## Public Input No. 3-NFPA 13E-2023 [ New Section after 3.3.2.3 ]

**Public Input No. 13-NFPA 13E-2023 [ Section No. 5.1.4 ]**

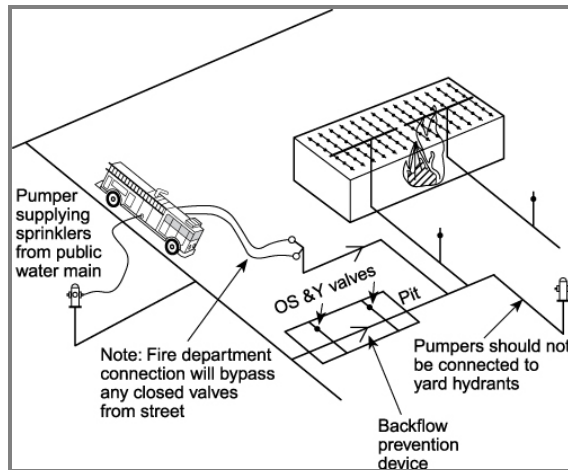
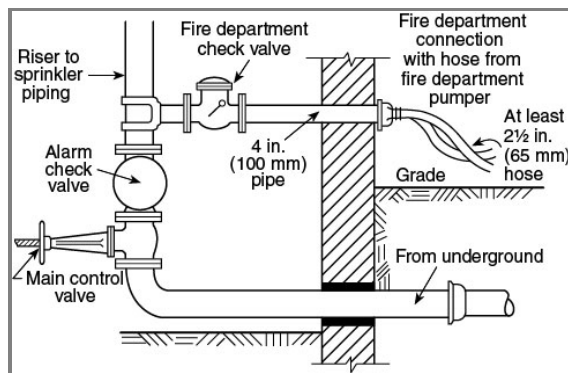
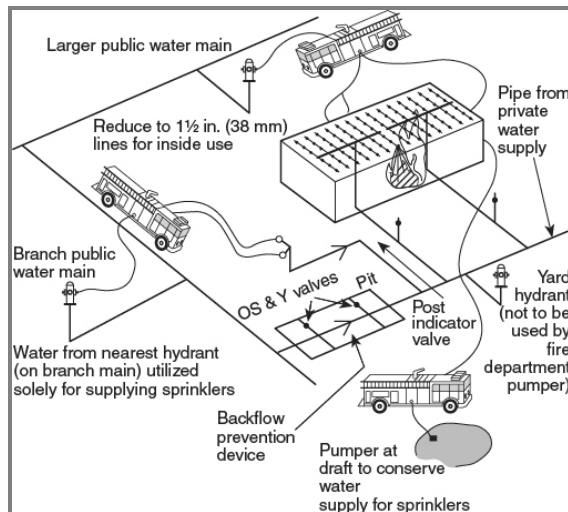
5.1.4 \* When arriving at a property protected by an automatic sprinkler system, fire companies should take prompt action to supply, supplement, the system. [See Figure 5.1.4(a) and Figure 5.1.4(b).] A minimum of one sprinkler supply line should be connected to the fire department connection and should be supplemented according to fire conditions. The supply line should be pumped and the line charged and maintained to a pressure of 150 psi (10.3 bar) unless the system is posted for a different pressure. Additional hose lines should be stretched to the fire area as directed by the incident commander in charge. [See Figure 5.1.4(c).]

Substantiation: NFPA 13 requires fire department connection on sprinkler systems to be able to provide supplemental water supply for automatic fire sprinklers. Fire sprinkler systems have automatic water supplies and only require supplementation. The pressure should be maintained to provide a supplement water supply as more sprinklers activate beyond the design area, exceeding the automatic water supply.

**Resolution:** [FR-3-NFPA 13E-2024](#)

**Statement:** NFPA 13 requires fire department connections on sprinkler systems to be able to provide supplemental water supply for automatic fire sprinklers. Automatic fire sprinkler systems have automatic water supplies and only require supplementation. The committee also recognizes that higher hazard buildings are often equipped with very large fire sprinkler systems capable of flowing large quantities of water. These systems may require a greater volume of water to supplement the system in large fires.
